WEST SUSSEX COUNTY COUNCIL CONSULTATION

TO:	Arun District Council FAO: Amber Willard
FROM:	WSCC - Highways Authority
DATE:	4 December 2020
LOCATION:	16 North End Road Arundel BN18 0DJ
SUBJECT:	Y/129/20/HH Installation of vehicular crossover.
DATE OF SITE VISIT:	n/a
RECOMMENDATION:	More Information
S106 CONTRIBUTION TOTAL:	n/a

Vehicle Visibility Splays

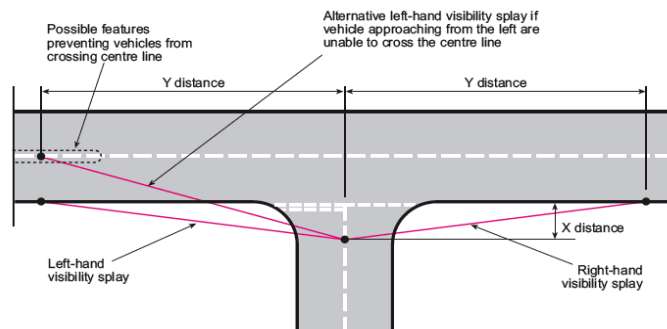
Visibility splays have not been provided alongside this most recent application, the Local Highways Authority (LHA) therefore advise the applicant to provide maximum achievable visibility splays for the proposed access point.

All Visibility splays must include a 2.4 metre setback distance from the kerb edge and span in both directions to no more than 1 metre from the kerbed edge. The splays must

not intersect third party land, be located solely within land under the control of the applicant or within the Publicly Maintained Highway and include the current road geometry. We have provided a diagram below for your guidance only.
